HURON-CLINTON METROPOLITAN AUTHORITY
FLATROCK DAM 2008 REPAIRS

AS-BUILT ("A.B.") DRAWING NOTES	JRR	By	Appd.	01.10
Revision				MM.DD.YY
BID SET				05.08
OWNER REVIEW				03.08
QA/QC (95%)				02.08
ROAD COMMISSION SUBMITTAL (WCOPS)				01.08
REVISIONS PER MDO				12.13.07
PERMITS (90% SET)				10.31.07
60% REVIEW				07.07.10
Issued		By	Appd.	MM.DD.YY

SOIL EROSION CONTROL AND MISC. DETAILS

**RIGHT SIDE, LOCK
DEMOLITION PLAN**

Stantec Consulting Michigan Ltd.
3959 Research Park Drive
Ann Arbor MI U.S.A.
48108-2216
Tel. 734.761.1010
Fax. 734.761.1200
www.stantec.com

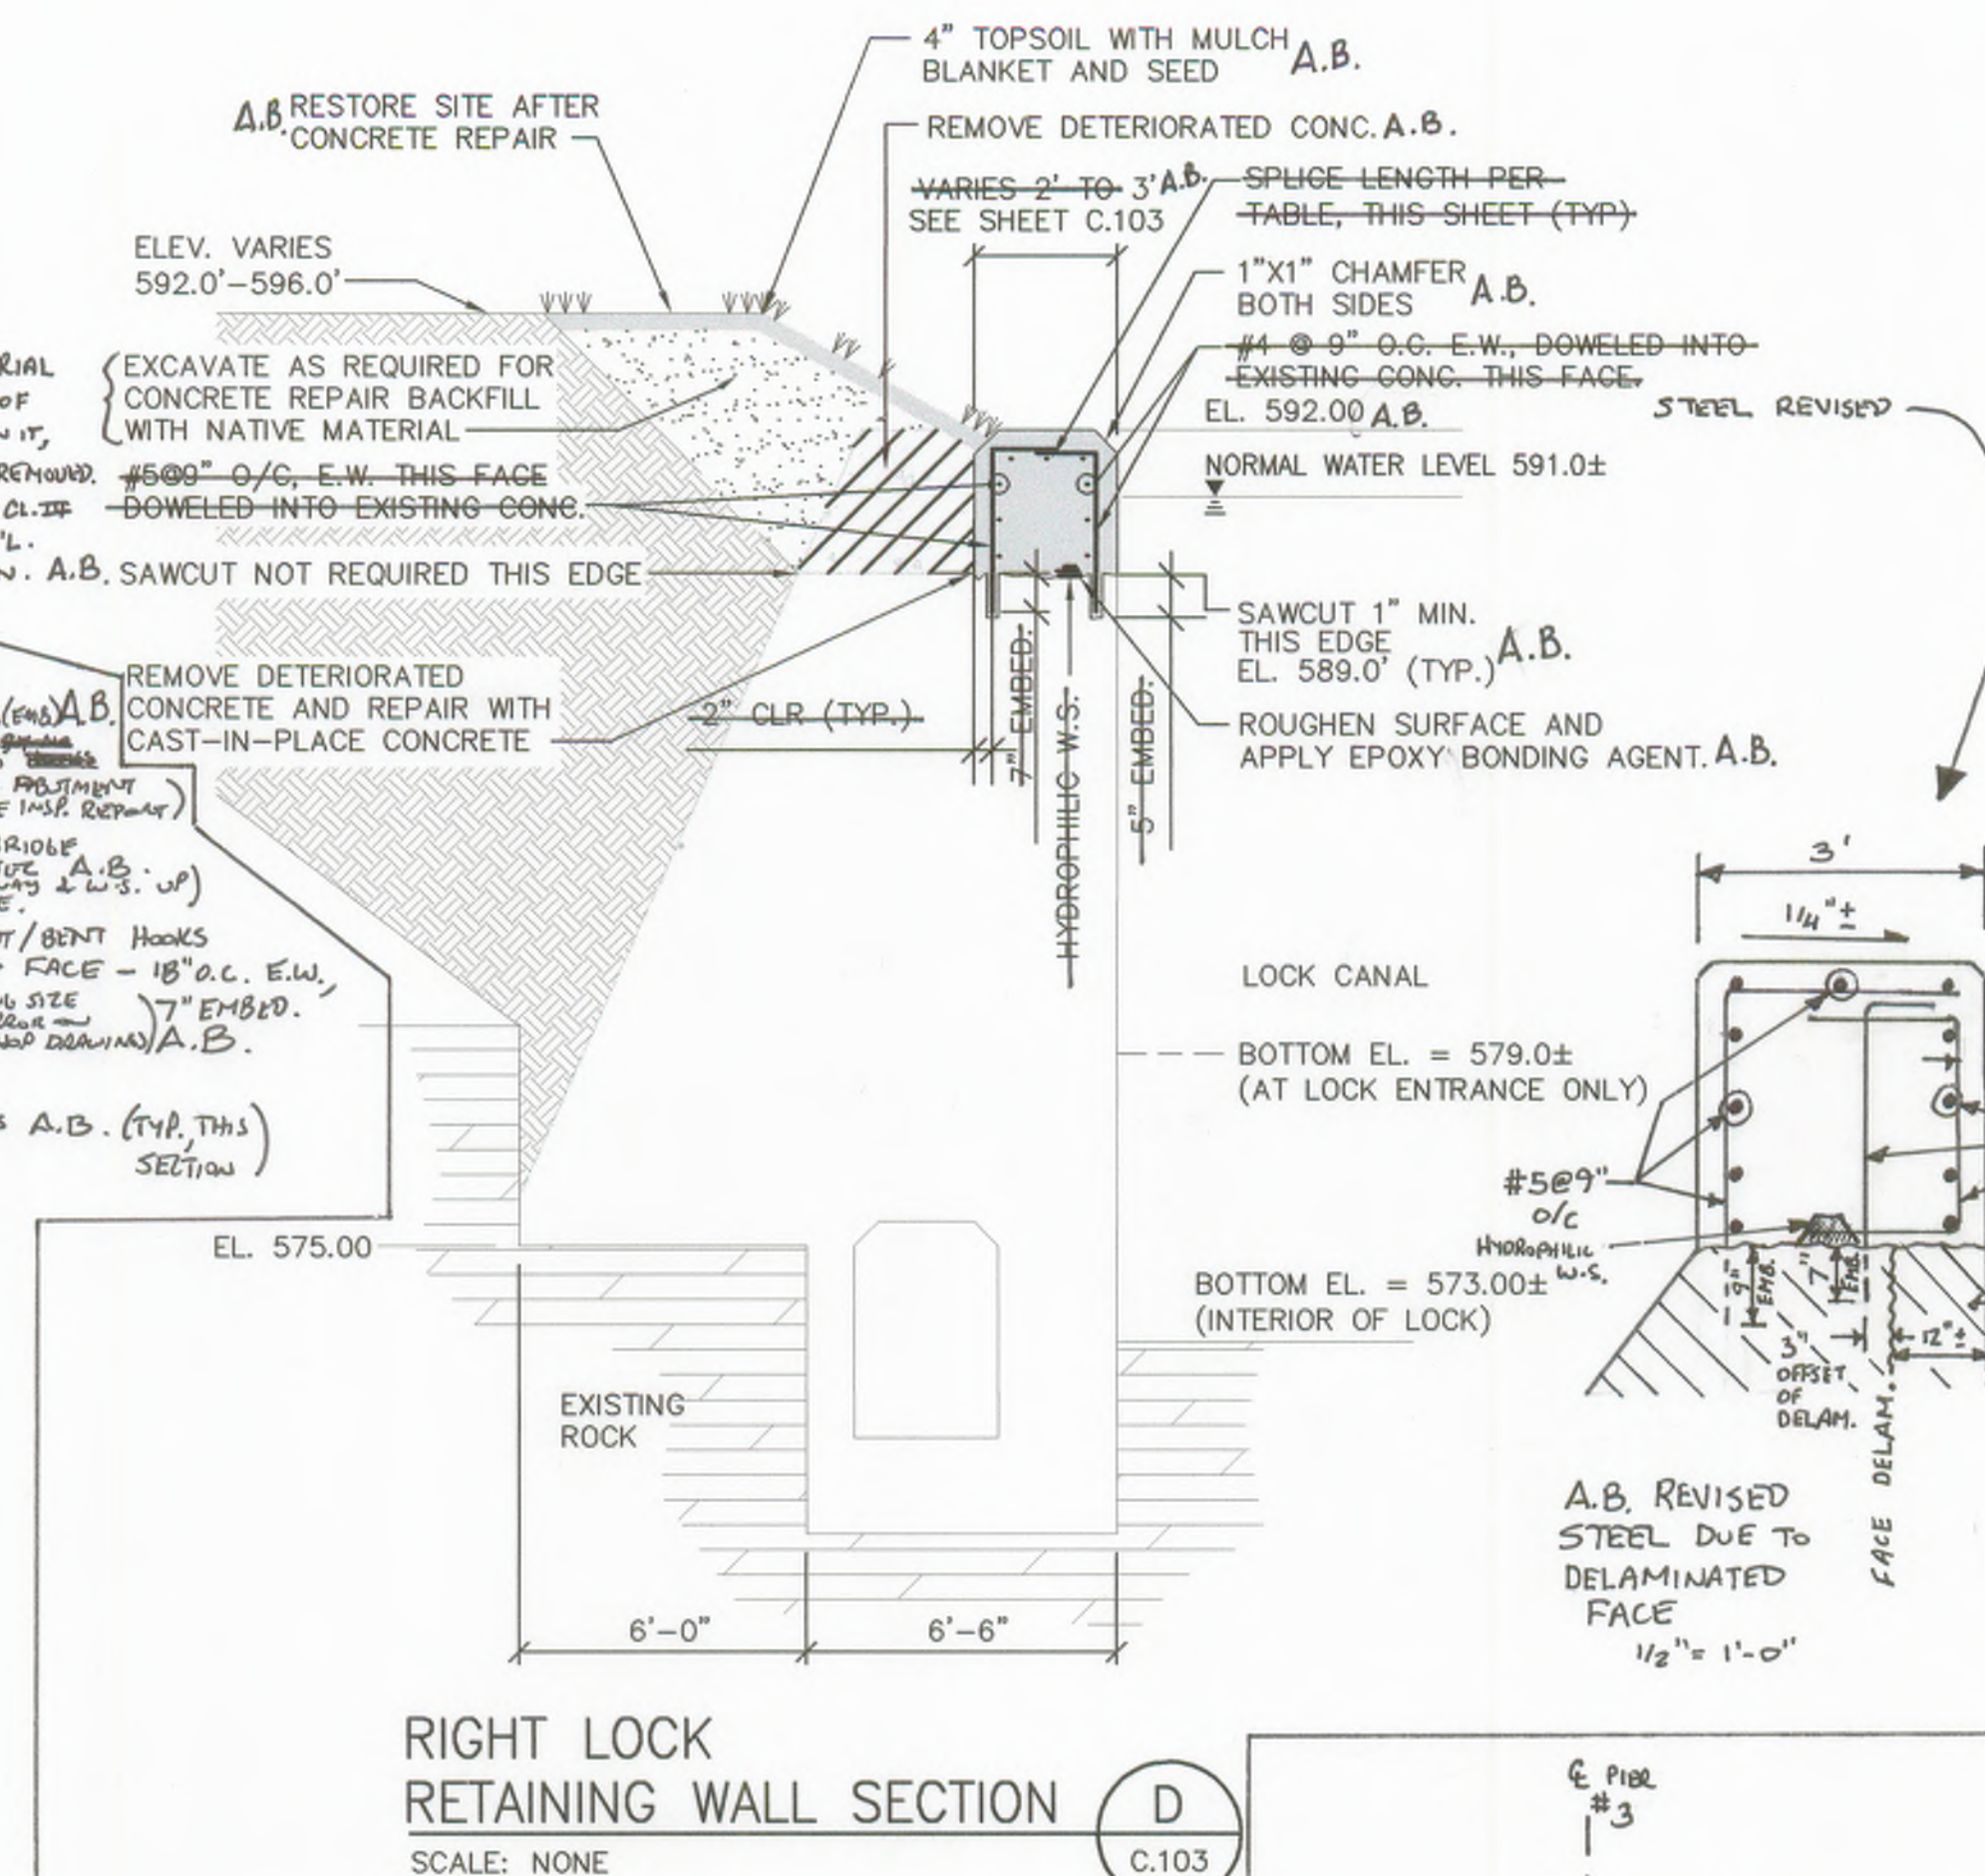
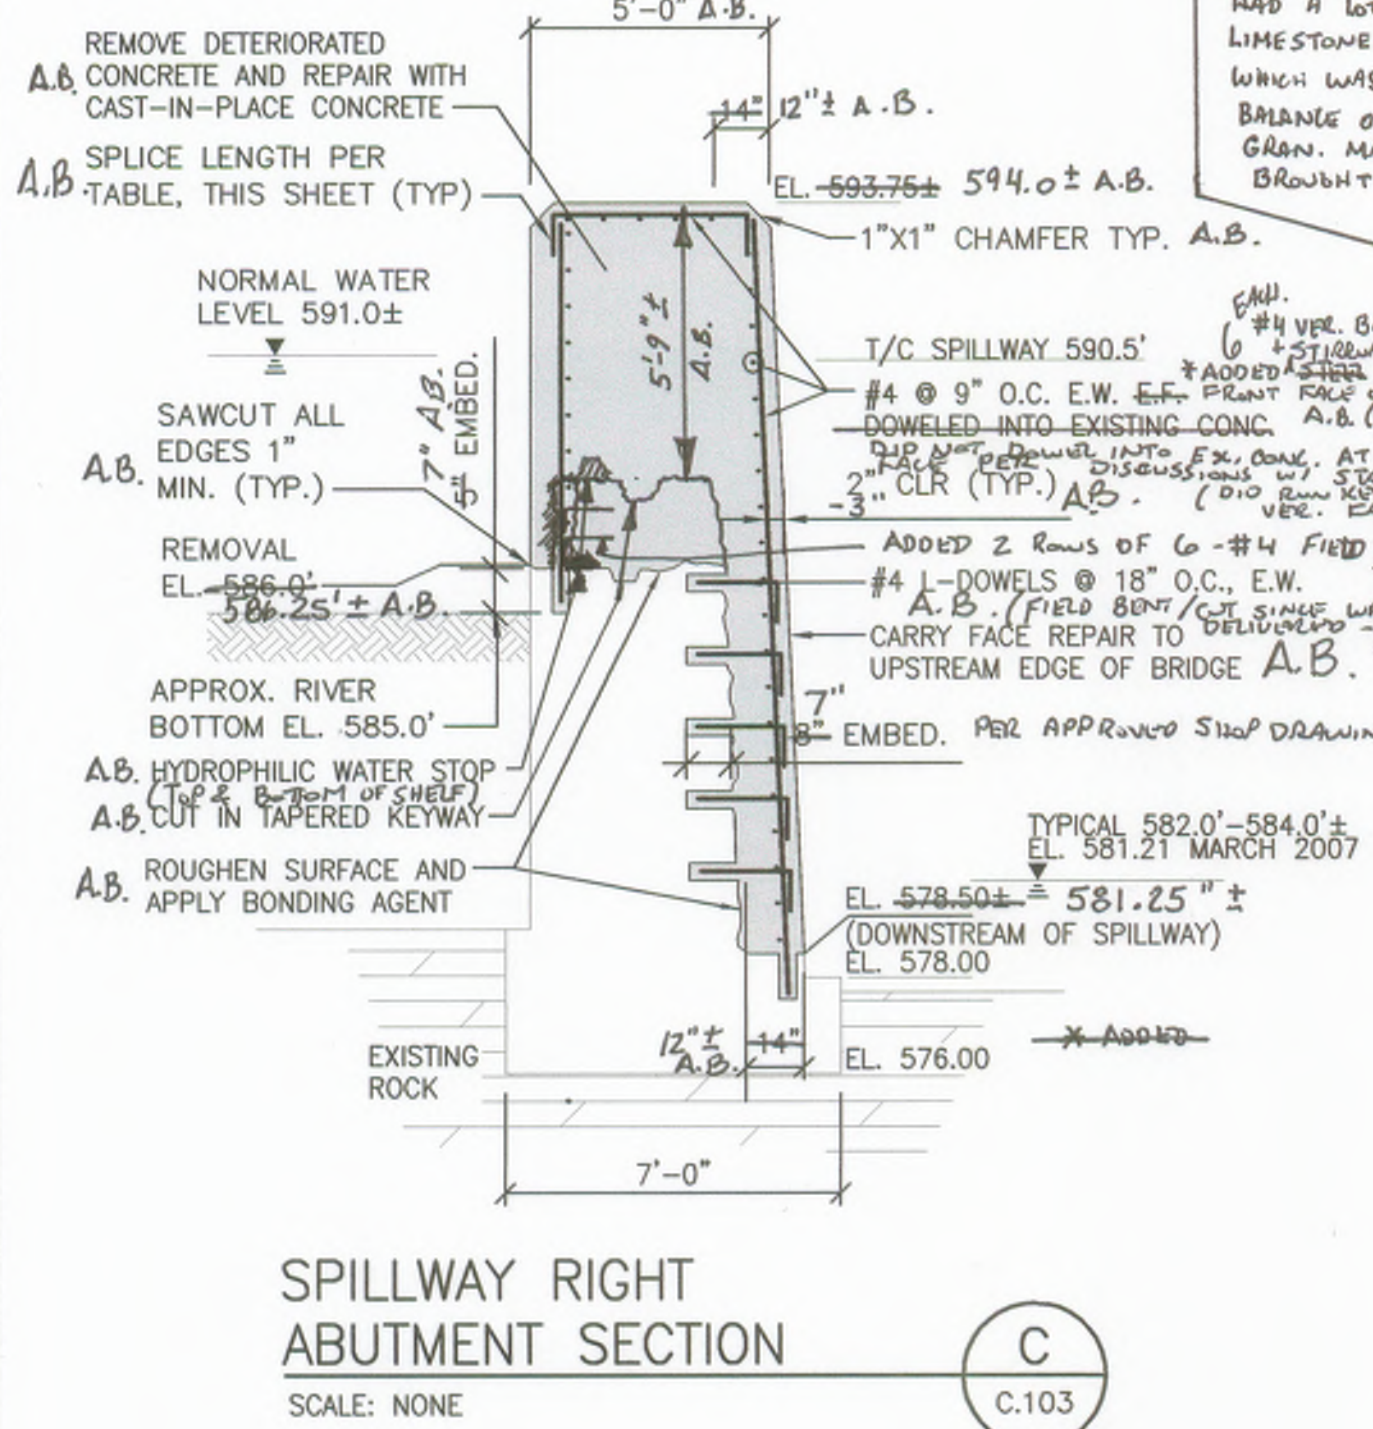
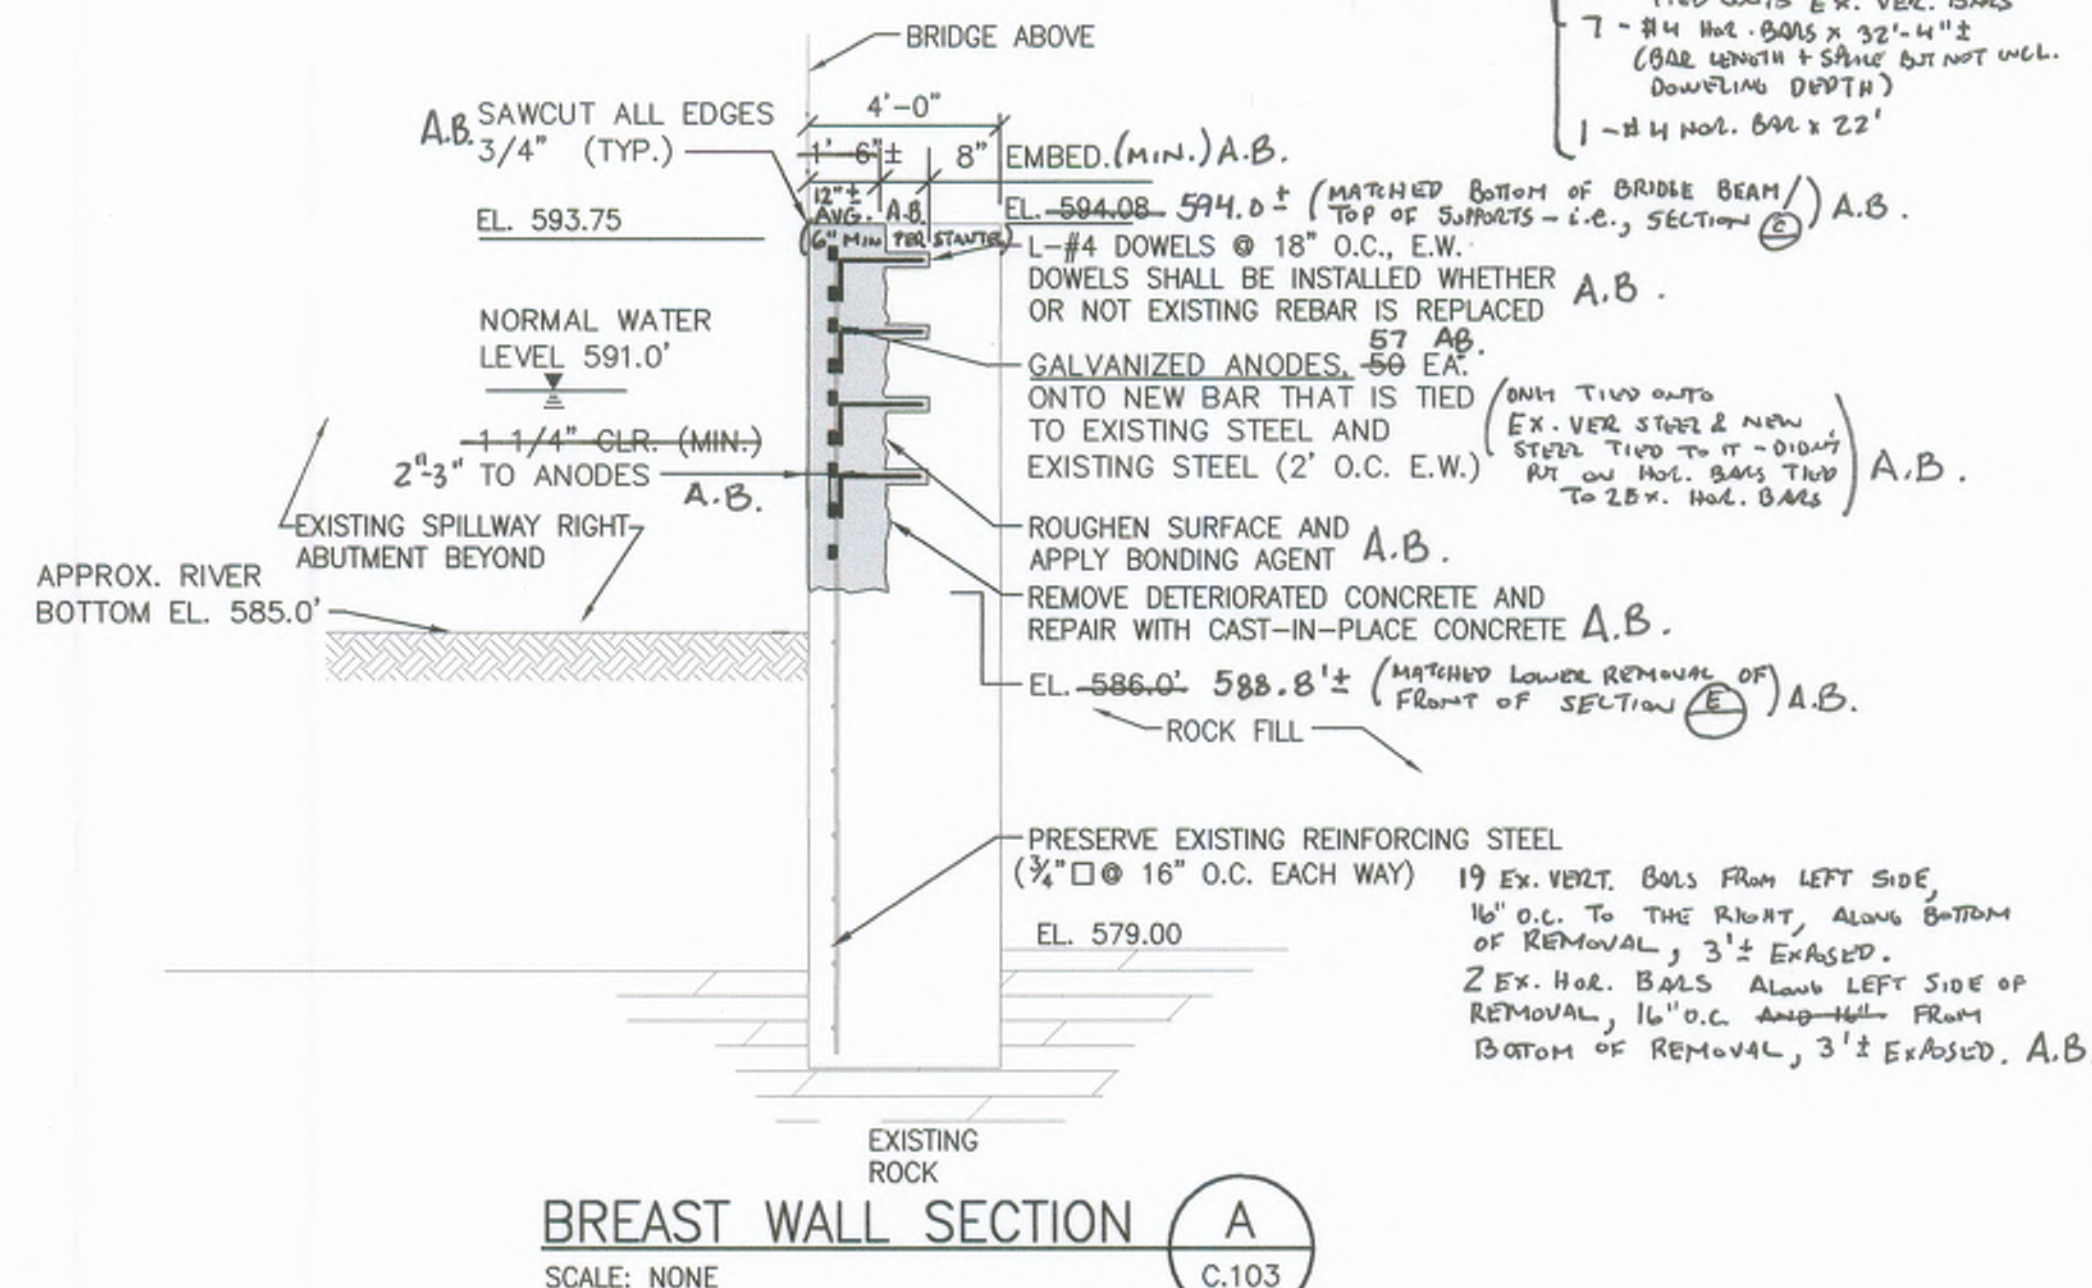
ADDITIONAL REBAR: 500 LBS. 330 LBS. A.B.
ADDITIONAL DOWELS: 440 EA. 40 EA. A.B.

(DOWELS ON 2 SIDES
& BOTTOM ONLY, NO DOWELS
INTO EX. BRIDGE BEAM ABOVE) A.B.

1. (APPLY TO ALL CONCRETE REPAIRS)
1. ROUGHEN ALL CONTACT SURFACES OF EXISTING CONCRETE TO CSP 6 OR 7 AS ESTABLISHED BY THE INTERNATIONAL CONCRETE REPAIR INSTITUTE (OR 1/8" ± PROFILE). CLEAN EXISTING REBAR. TREAT ALL REBAR AND CONCRETE CONTACT SURFACES WITH SIKKA ARMATEC 110. A.B. NOTE: HEMA ENHANCER ALLOWED W/ WELD-CRETE BONDING AGENT SINCE ITS OPEN TIME IS 7-10 DAYS, VS. SIKKA 10 OF 16 HOURS. DUE TO LOGISTICS OF SETTING REPAIRS & POURING CONCRETE, FOR REPAIR SECTIONS B, C, & J ONLY, (REBAR NOT TREATED PER STANTEC).

2. UNLESS OTHERWISE SHOWN, #4 DOWELS SHALL BE EMBEDDED 5" ON EDGE AND 8" ON FACE; #5 DOWELS 7"; AND #6 DOWELS 18". ALL DOWELS SHALL BE EPOXY SET WITH MULTI-HIT 150 OR HIT ICE. A.B. OR AS SHOWN ON APPROVED STEEL SHOP DRAWINGS. A.B. HILTI HIT RE 500 (EXCEPT A FEW LOCATIONS WHERE A BAR WAS ADDED PRIOR TO A.B., THEN, HIT 150 WAS USED FOR QUICKER CURE TIME).
